CITY OF ALBUQUERQUE

**Re: American Toyota
5995 Alameda NE
90-Day Temporary Certificate of Occupancy- Transportation Development
Engineer's Stamp dated 12-18-14 (C18D012)
Certification dated 6-2-17**

SITE PLAN

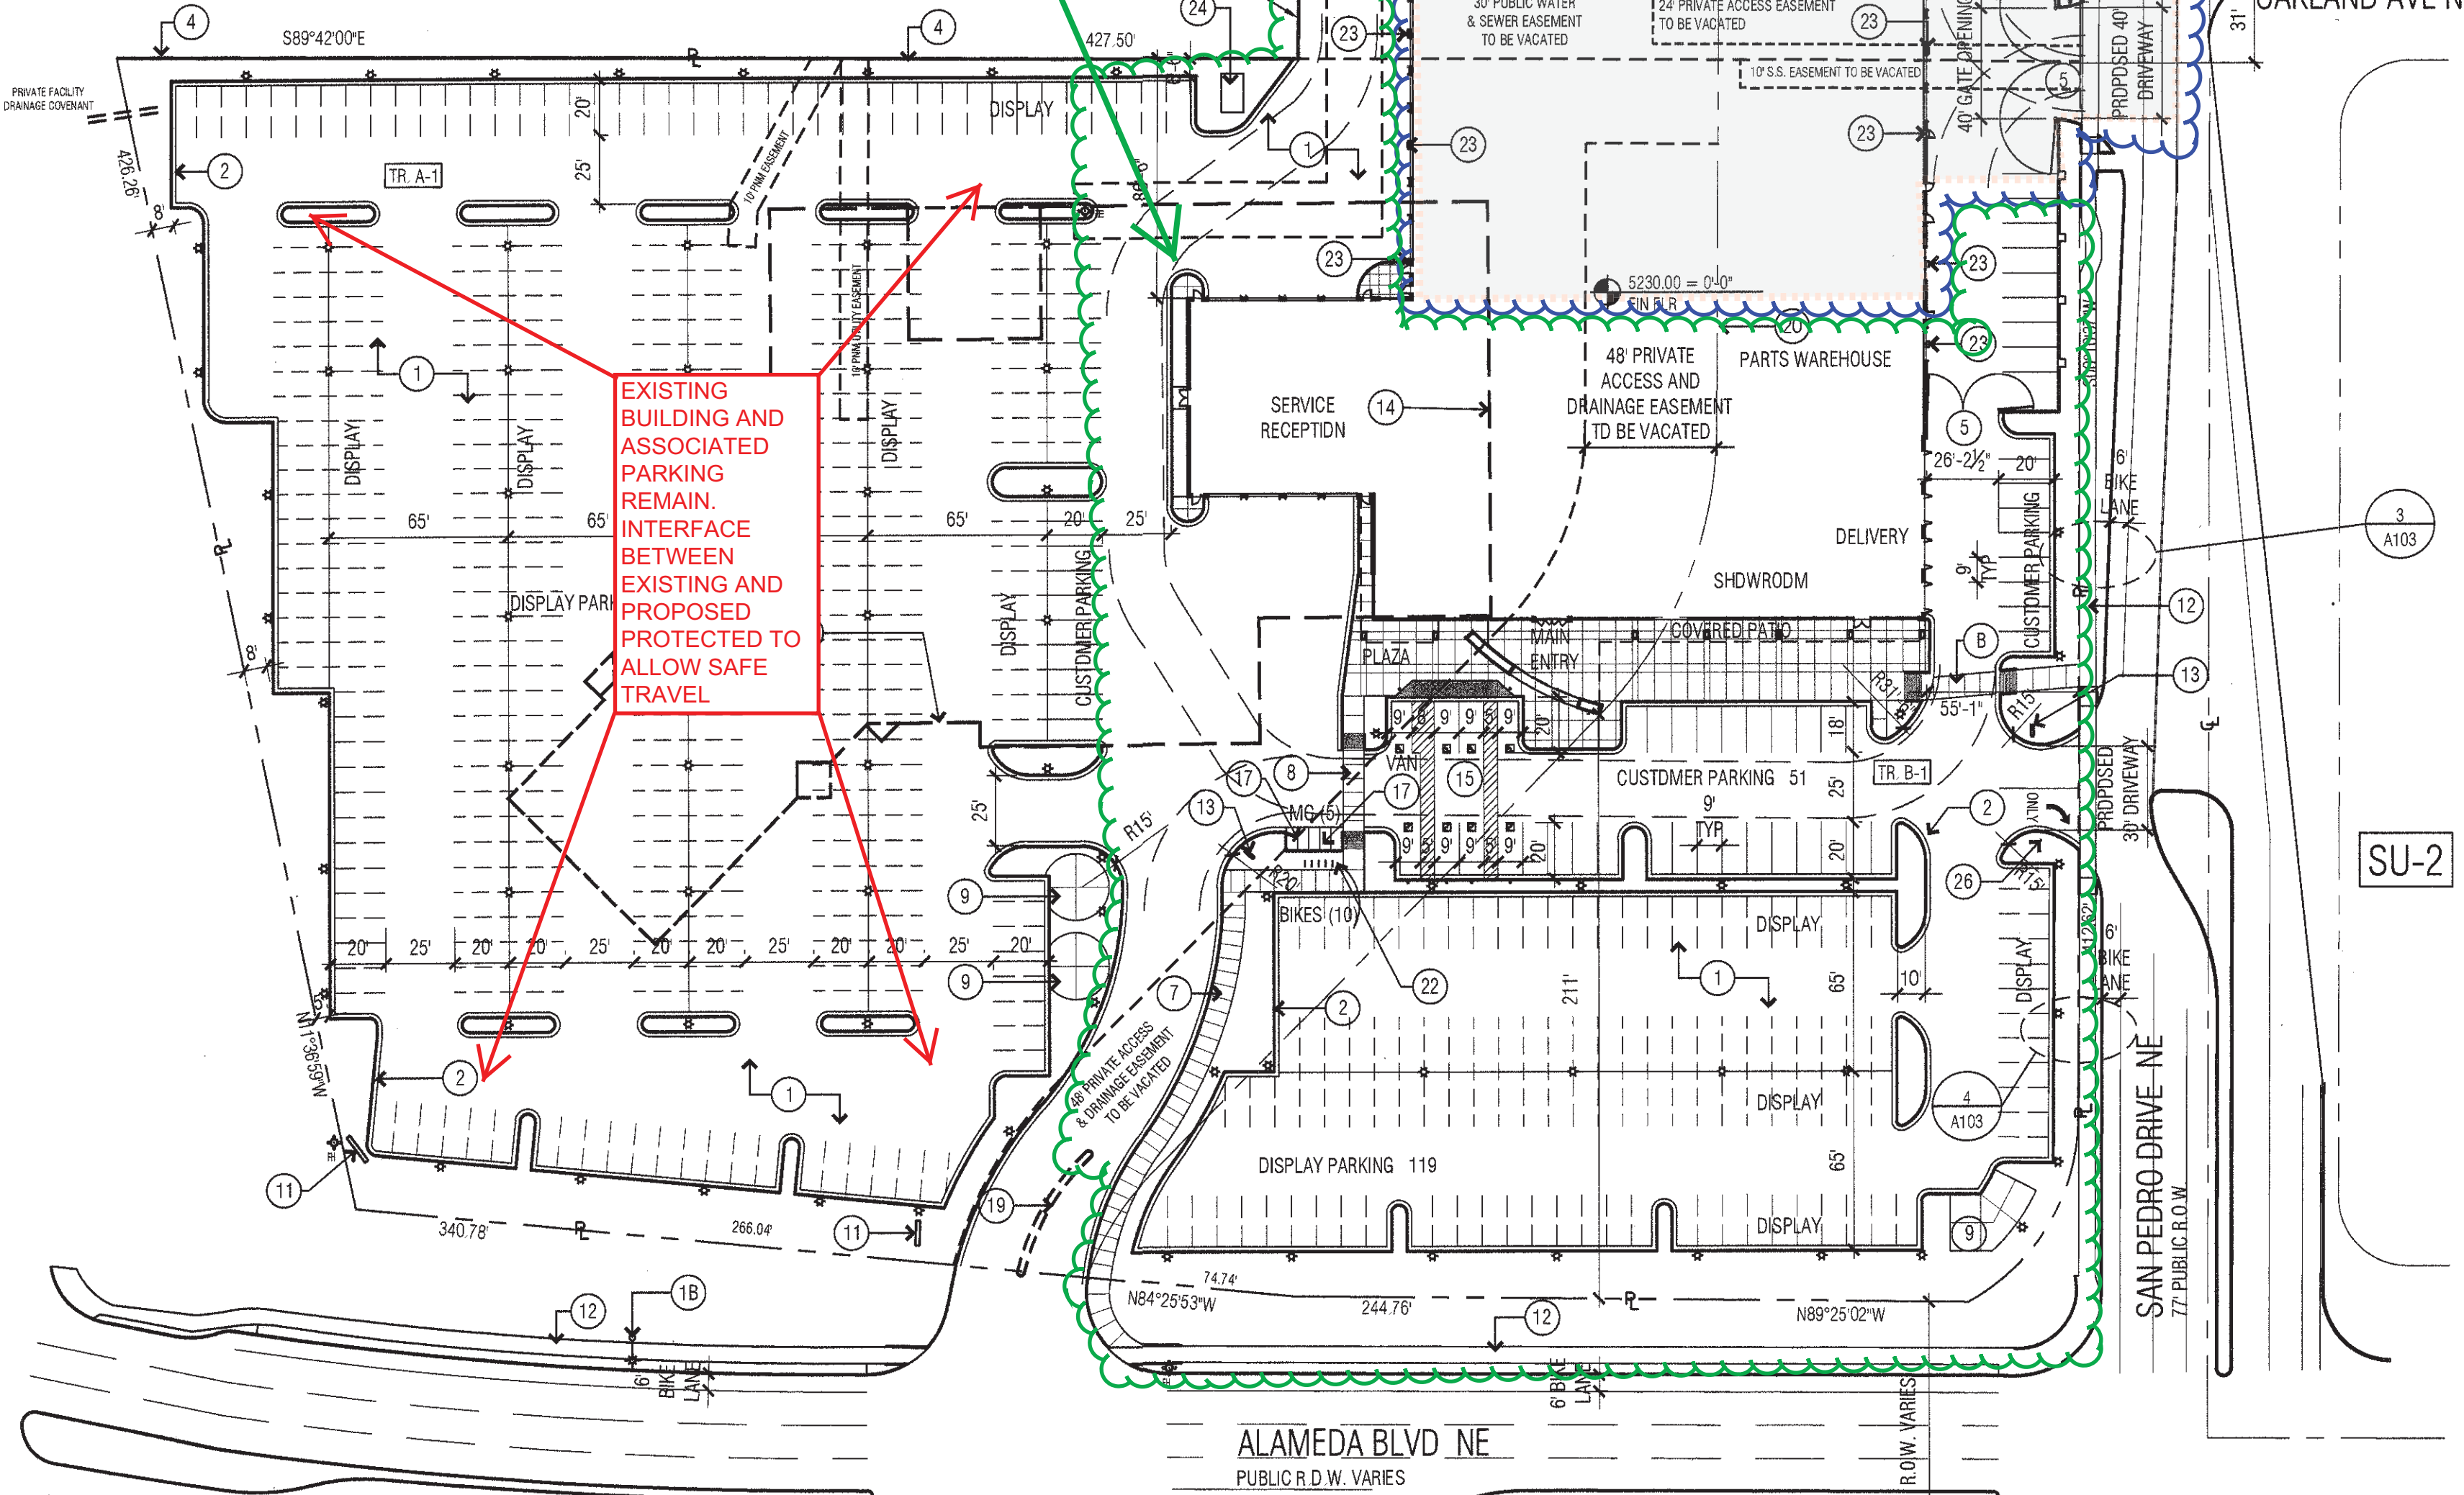
1. The ADA accessible parking sign must have the required language per 66-7-352.4C NMSA 1978 "Violators Are Subject to a Fine and/or Towing." Please call out detail and location of HC signs.
2. The ADA access aisles shall have the words "NO PARKING" in capital letters, each of which shall be at least one foot high and at least two inches wide, placed at the rear of the parking space so as to be close to where an adjacent vehicle's rear tire would be placed. (66-1-4.1.B NMSA 1978)
3. All crates and constructions equipment must be removed prior to permanent CO.
